**FORM VT-3C**  
 CONTAINMENT INSERVICE INSPECTION  
 RECORD OF VT-3C EXAMINATION

STATION/UNIT: Indian Point 2 COMPONENT NO.: VCC-05  
 ZONE NUMBER: IWL-043-002 DRAWING NO.: 320842  
 EQUIPMENT USED: Mag-Lite flashlight (see note 4)

Work Order No. NP-99-11274

**CONCRETE INSPECTION ZONE IWL-108-002**  
 (EXTERIOR DEVELOPED VIEW, LOOKING FROM OUTSIDE)

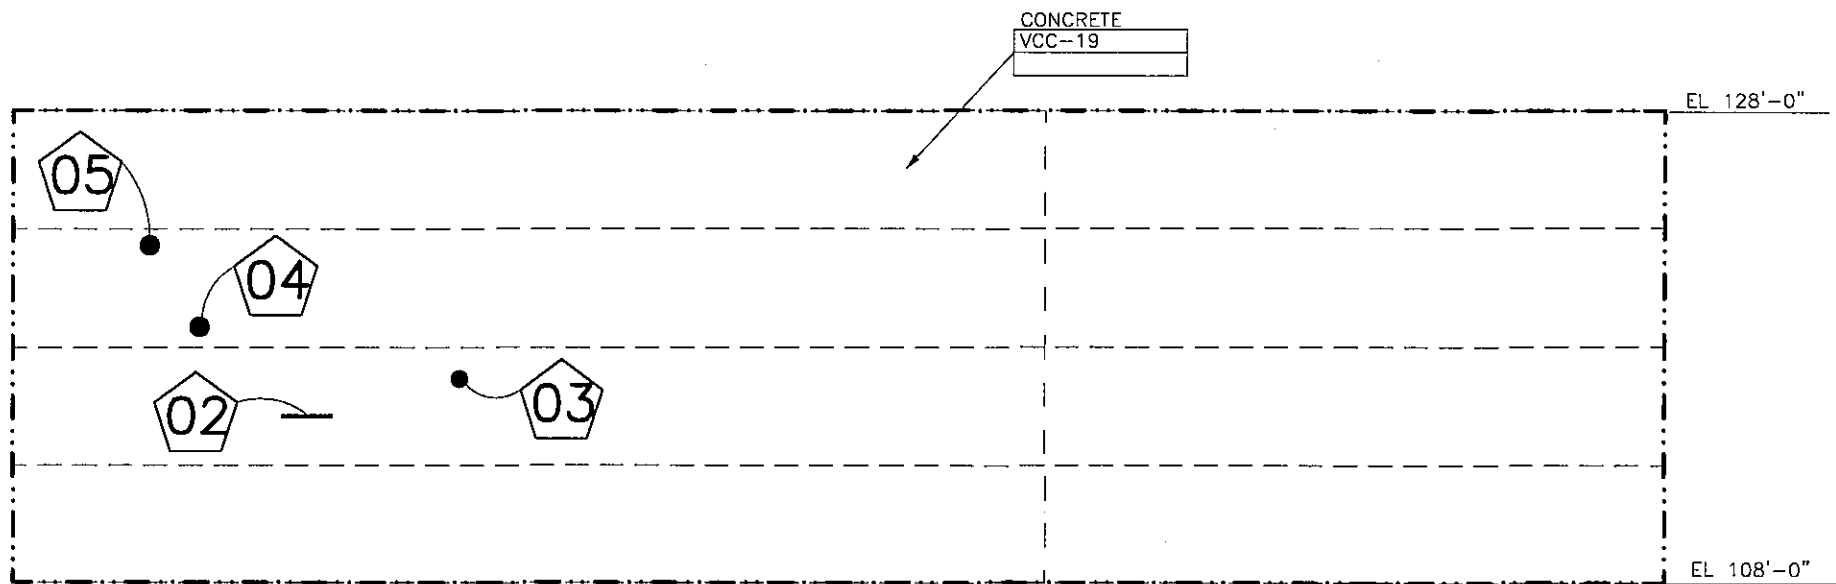
No.	Comment	Initials
1	Non-uniformity of surface color and texture observed at various locations in the zone. The condition does not indicate significant material deterioration of the concrete.	CAS
2	Exposed cadweld (approx. 9" long) with corrosion apparently due to inadequate cover. See photo 00060116	CAS
3	A small spot of corrosion appears on the concrete surface. It is not apparent whether this is reinforcing steel, a cadweld or miscellaneous steel. See photo 00060117.	CAS
4	A small spot of corrosion appears on the concrete surface. It is not apparent whether this is reinforcing steel, a cadweld or miscellaneous steel. See photo 00060118	CAS
5	Leaching is evident approximately 18" long extending downward from the construction joint.	CAS

Comments: Engineering evaluation is required for the exposed reinforcing steel (comment #2, #3 & #4). The leaching (comment #5) is not significant. The surface texture (comment #1) results from original construction and does not reflect degradation.
